CRIME IMPACT STATEMENT

Land bound by Goulden St, Chadderton St, Marshall
St and Cross Keys St, New Cross

99 No. Apartments

REFERENCE: 2023/0422/CIS/01

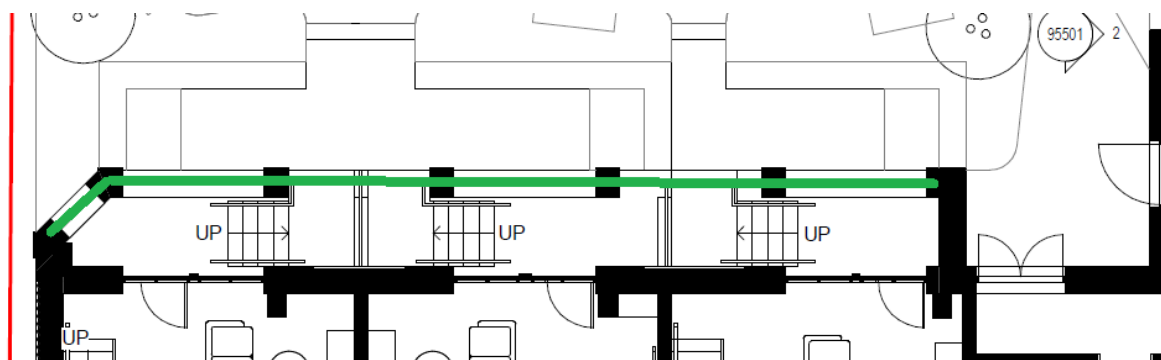
- 3.3.1 Access the lower ground floor duplex apartments is taken from a lower level than the courtyard area, these spaces might not be readily visible from the courtyard/public footway/highway which could leave residents, visitors, and the apartments vulnerable. To reduce the potential for misuse it is highly recommended that a low boundary (i.e. 1200-1500mm railings) and lockable gate are installed to restrict access to residents.

- 3.3.2 Vehicular access into the landscaped area should be prevented with bollards, trees, planters, or similar.
- 3.3.3 Views of, and within, the landscaped courtyard should be unimpeded, with low shrubbery not exceeding 1000mm and tree canopies falling no lower than 2400mm. The courtyard should be covered by a monitored CCTV system and there should be a management/security protocol for dealing with antisocial behaviour.

- 3.3.4 External communal access doors must be compliant with and certified to BS PAS 24, STS202, or LPS 1175 SR2, including a lock capable of being operated via an electronic access control system. The communal entrance doors should be self-closing and secured with a multi-point electronic lock and capable of being operated via an electronic access control system, these features should be permitted under the scope of the certification.

- 3.3.5 Access into the buildings should be controlled by a video entry phone system (with the picture viewable on the phone unit, rather than on a television set) so that residents can vet visitors before allowing them access into the building. There should be no unrestricted trade access into the building.

- 3.3.6 To prevent tailgating into the building there should be a secure lobby, with a residents/visitors passing through a second access control security rated door before they can enter the stair/lift core of the building.
